Douglas P. Jackson, PE
Comments Regarding the Mitigated Negative Declaration, Notice of Determination, & Initial Study
for the
Cypress Mountain Drive Bridge Replacement Project ED13-248/300432

Summary of Comments for the “Mitigated Negative Declaration, Notice of Determination, & Initial Study” for the San Luis Obispo County Bridge #49C0033

This summary offers concise findings regarding the “EXHIBIT A Cypress Mountain Drive Bridge Replacement Project ED13-248/300432 Mitigated Negative Declaration, Notice of Determination, & Initial Study,” hereinafter referred to simply as “**Document**”, for the Federally funded Highway Bridge Replacement and Rehabilitation Program (HBRRP) bridge replacement of San Luis Obispo County Bridge No. 49C0033:

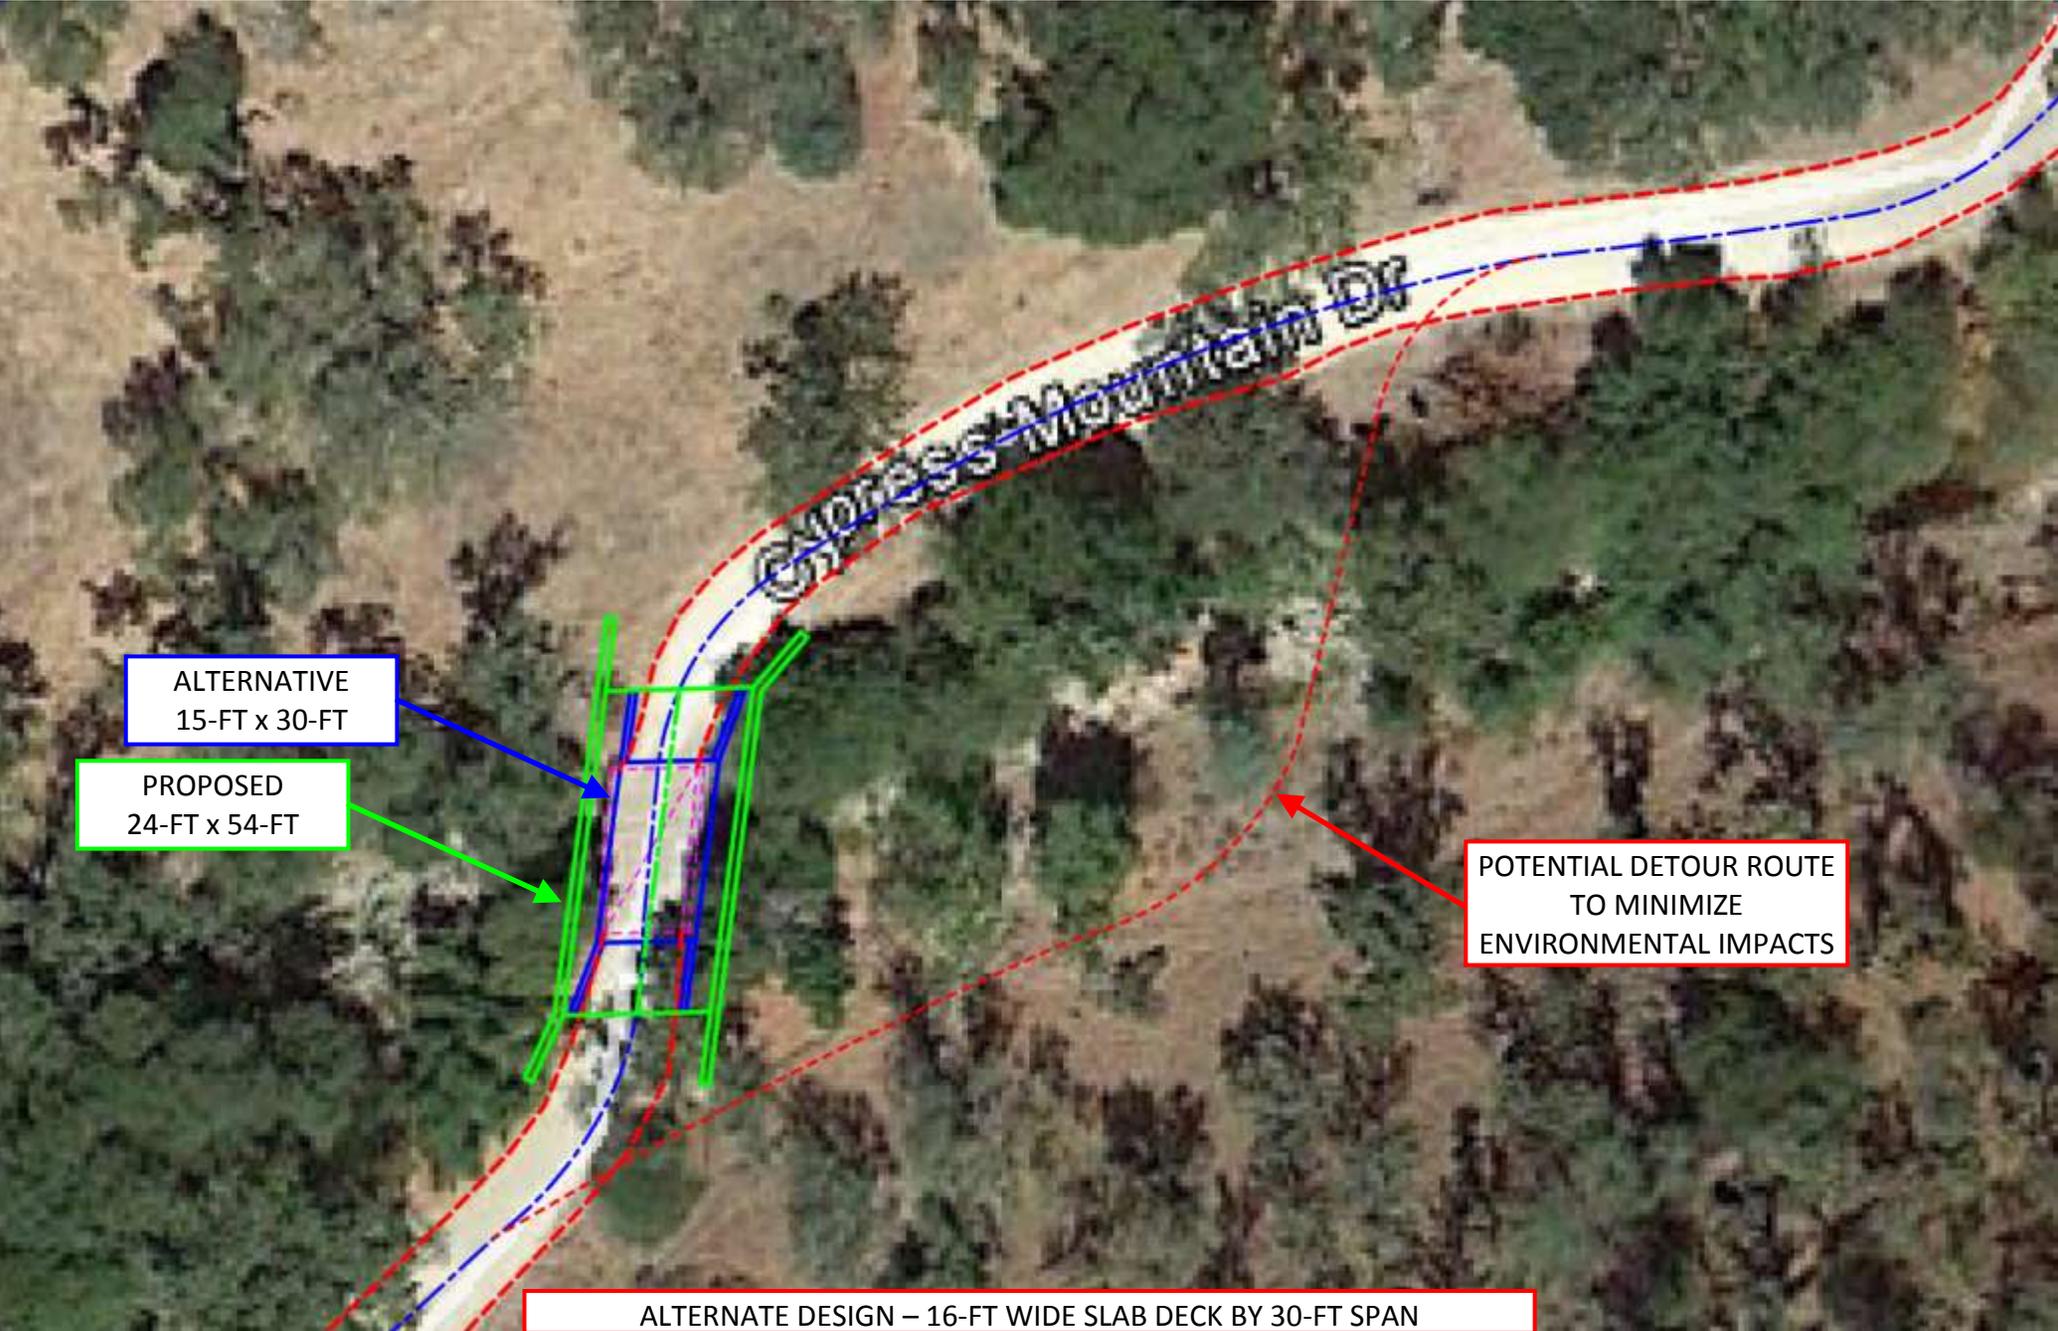
- **Page 1 of EXHIBIT 9** graphically illustrates a proposed plan layout including what is believed to be the approximate positioning of the proposed 24-foot wide by 54-foot span concrete slab deck bridge along with the proposed siting of the alternative 16-foot wide by 33-foot span concrete slab deck span.

ALTERNATE DESIGN - 16-FT WIDE SLAB DECK BY 30-FT SPAN

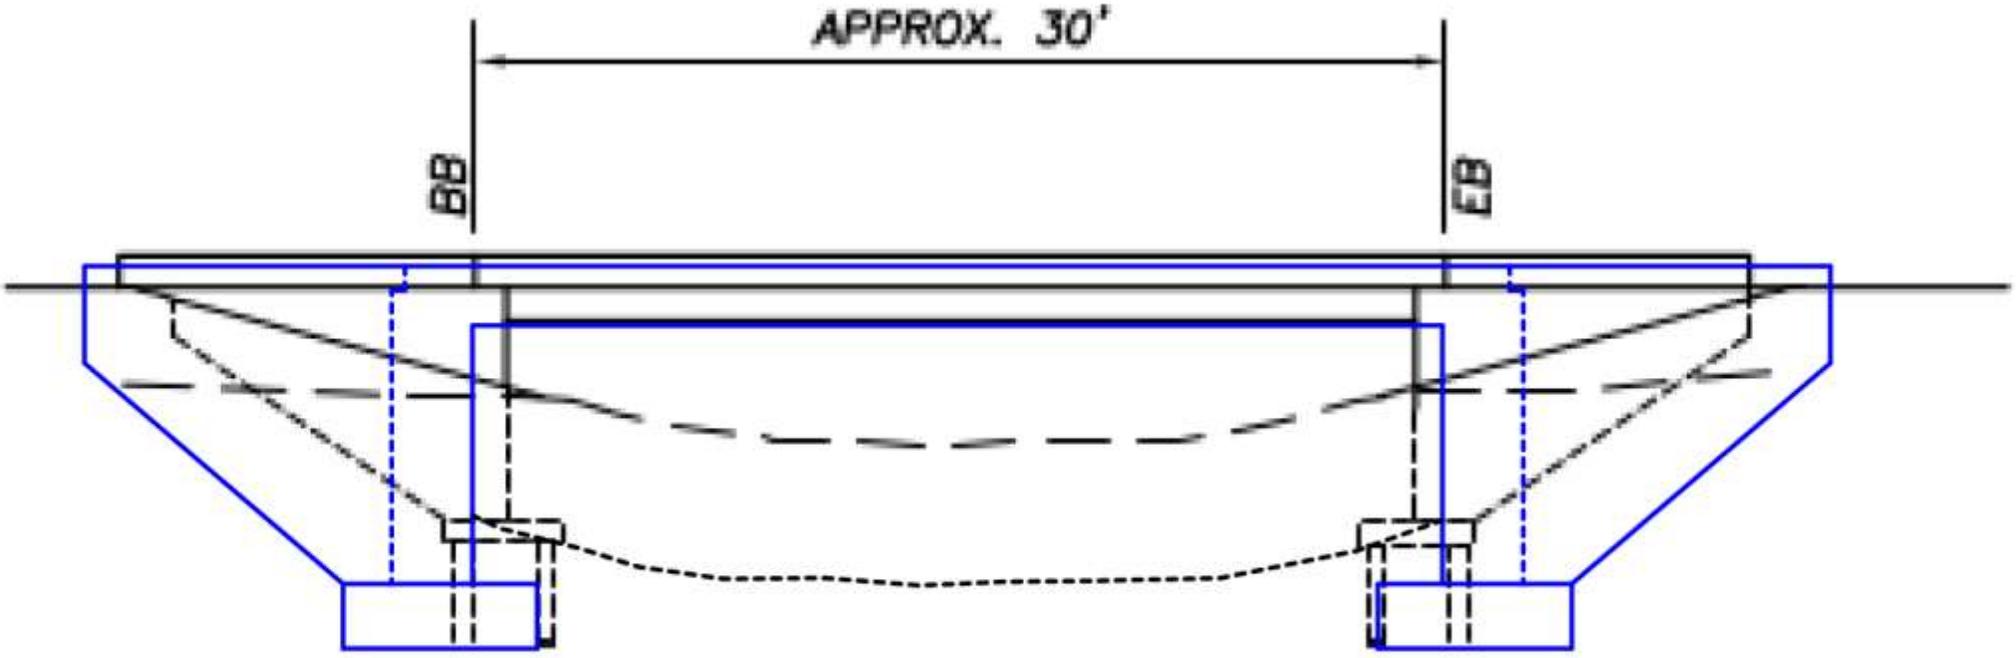
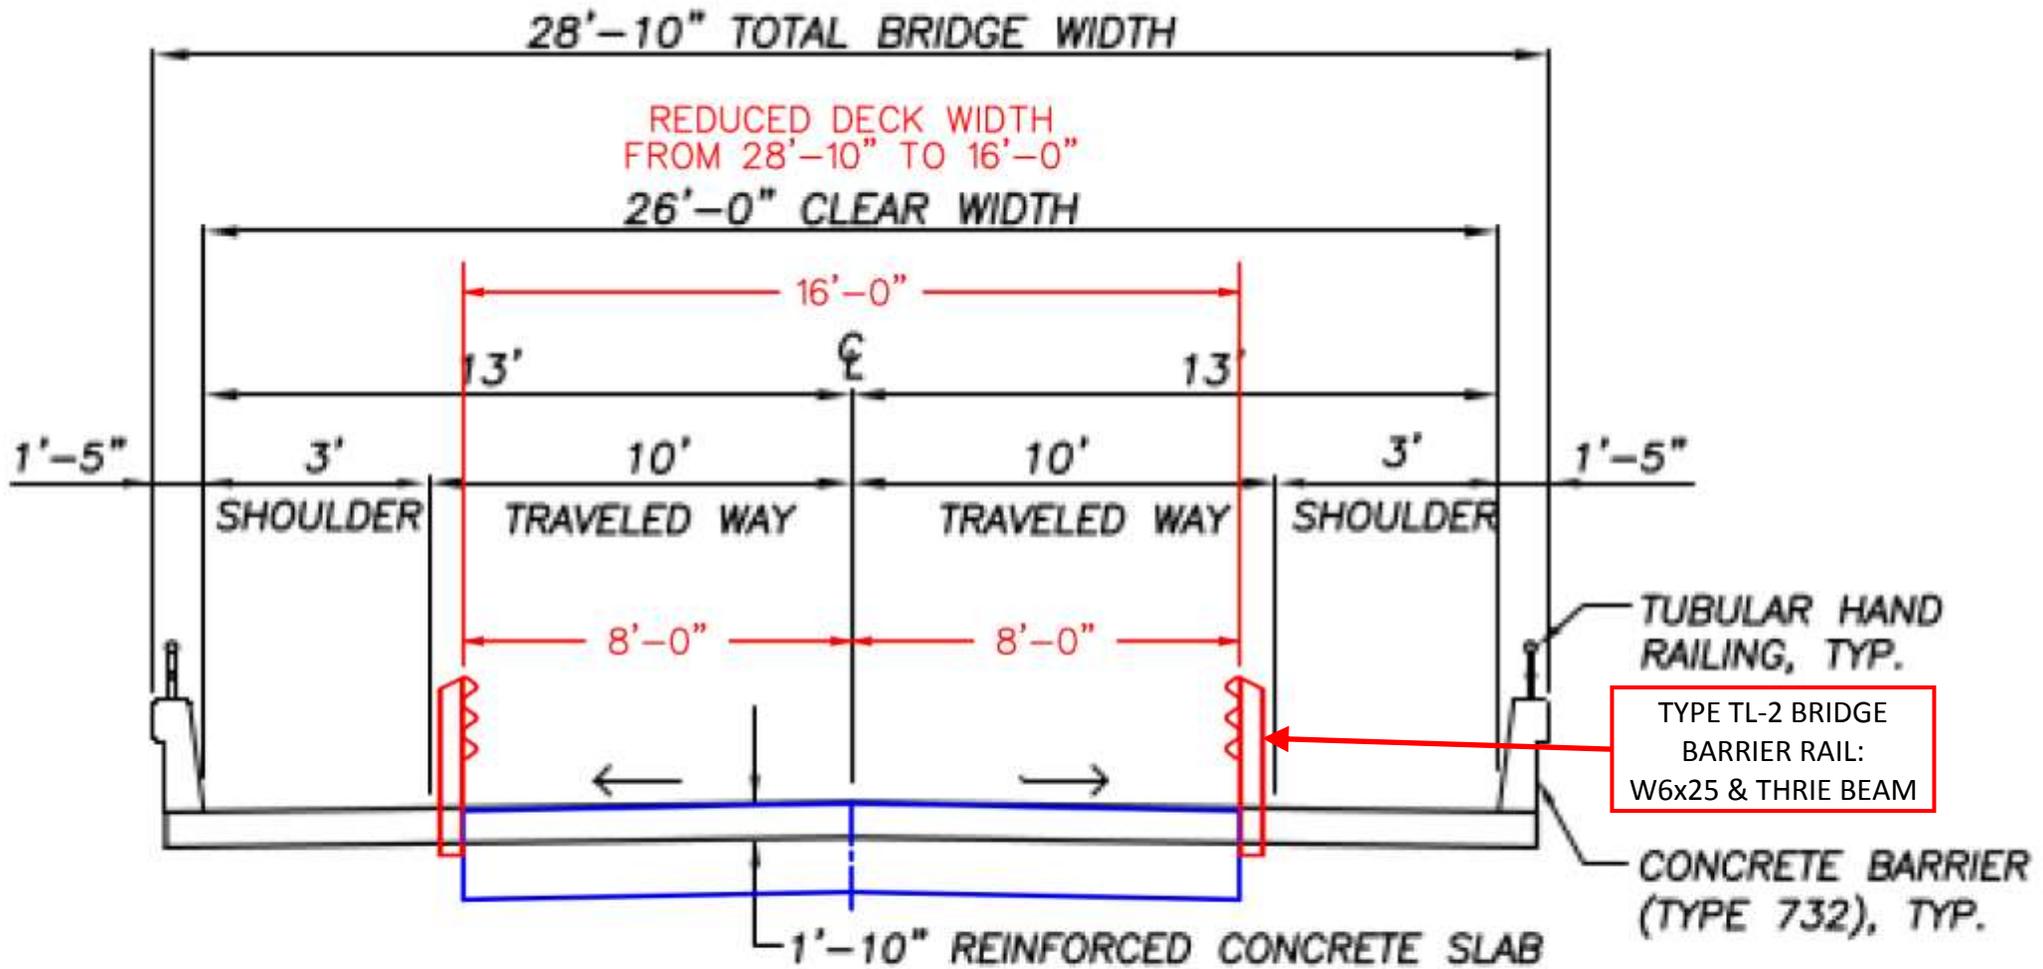
- A no-build alternative.
 - A replacement structure of single lane width of approximate existing span length meeting the AASHTO design standards for roadways where the Average Daily Traffic is less than 100 vehicles per day for both existing and projected traffic volumes out 20 years.

A one-lane bridge sixteen feet (16') in width may be provided pursuant to The Green Book as Cypress Mountain Drive is essentially a one-lane roadway with Average Daily Traffic less than 100 vehicles per day both currently and projected 20 years into the future, there are no plans to widen the roadway within the next ten years, and such a one-lane bridge can function effectively based upon the safety performance of the preexisting fourteen foot wide timber bridge structure having been in service since 1953.
